Detroit  
Edison

August 2, 1990  
NRC-90-0127

Subject: Proposed Technical Specification Change (License Amendment)-3.5.1, ECCS-Operating; 3.5.2, ECCS-Shutdown; 3.4.9.1, Reactor Coolant System - Hot Shutdown; 3.4.9.2, Reactor Coolant System - Cold Shutdown; 3.6.2.2, Containment Systems-Suppression Pool and Drywell Spray; 3.6.2.3, Containment Systems - Suppression Pool Cooling; 3.9.11.1, RHR and Coolant Circulation, High Water Level; 3.9.11.2, RHR and Coolant Circulation, Low Water Level

FIGURE 1: SIMPLIFIED RHR SYSTEM  
(DIVISION 2)

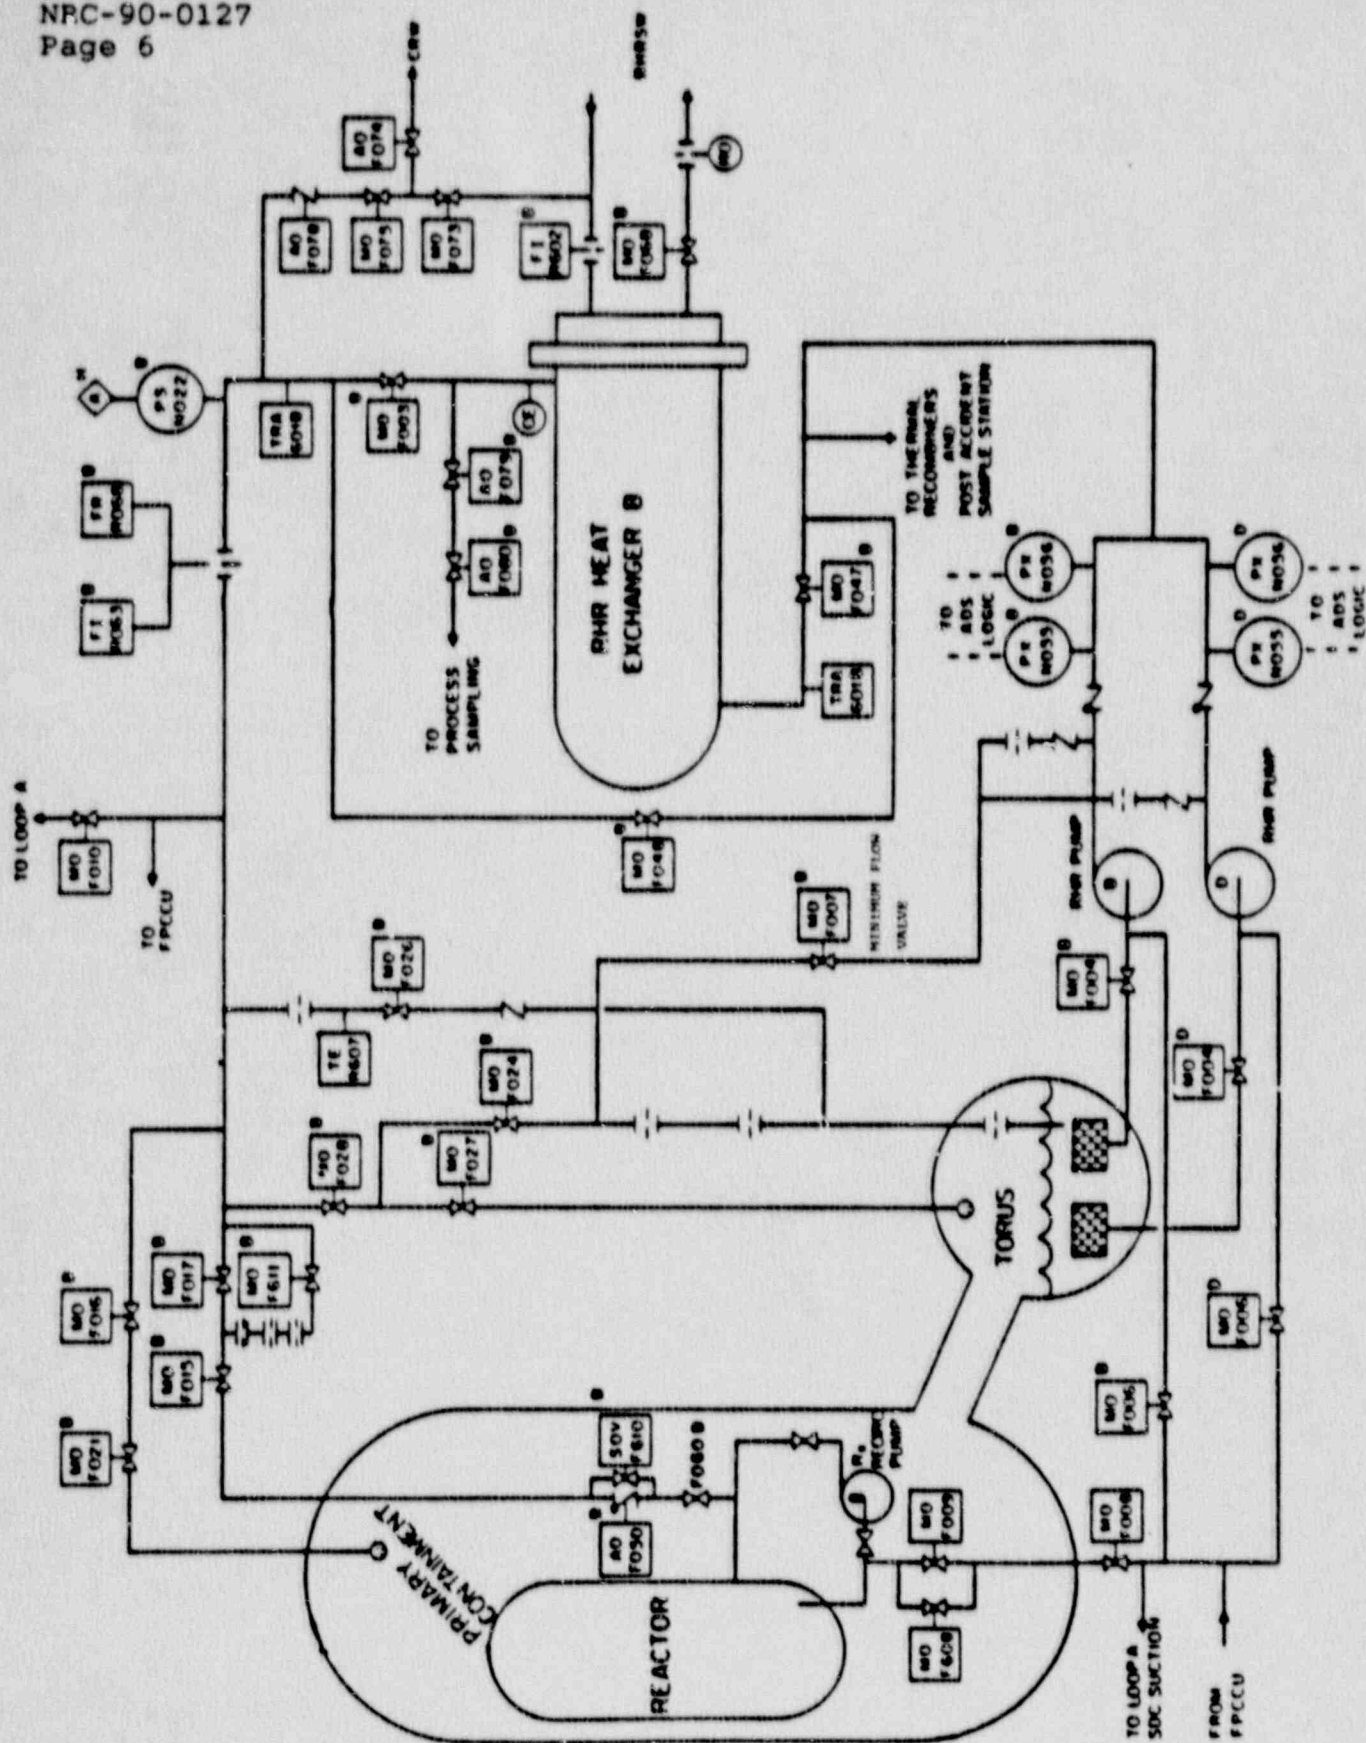
To eliminate this potential mechanism of reactor coolant inventory loss it is being proposed that the minimum flow valve be allowed to be deenergized in the closed position when the RHR pump suction is aligned to the reactor pressure vessel. This will prevent the valve from opening as a result of any unanticipated event. Because this valve is considered to be an integral part of attendant support features necessary to maintain the OPERABILITY of the RHR system, changes to Technical Specification sections 3.4.9.1, 3.4.9.2, 3.5.1, 3.5.2, 3.6.2.2, 3.6.2.3, 3.9.11.1, and 3.9.11.2 are necessary to implement this operating strategy. Detroit Edison proposes to add a footnote to these sections stating, "With the RHR pump suction path aligned to the reactor pressure vessel for shutdown cooling the RHR minimum flow valve may be deenergized in the closed position." These changes will permit the RHR system to remain OPERABLE in the shutdown cooling mode while the RHR minimum flow valve is disabled in the closed position.

valves. The system operating procedure provides detailed instructions on performing this evolution. Because flow is immediately established through the pump the minimum flow valve function is not required. It is therefore desirable to deenergize the minimum flow valve in the closed position to prevent any inadvertent reactor coolant inventory loss through the minimum flow line. The proposed change would be limited to those Operational Conditions where the potential to be in shutdown cooling exists, that is, in Operational Conditions 3 with reactor pressure less than the RHR cut-in permissive (95 psig), 4, and 5.
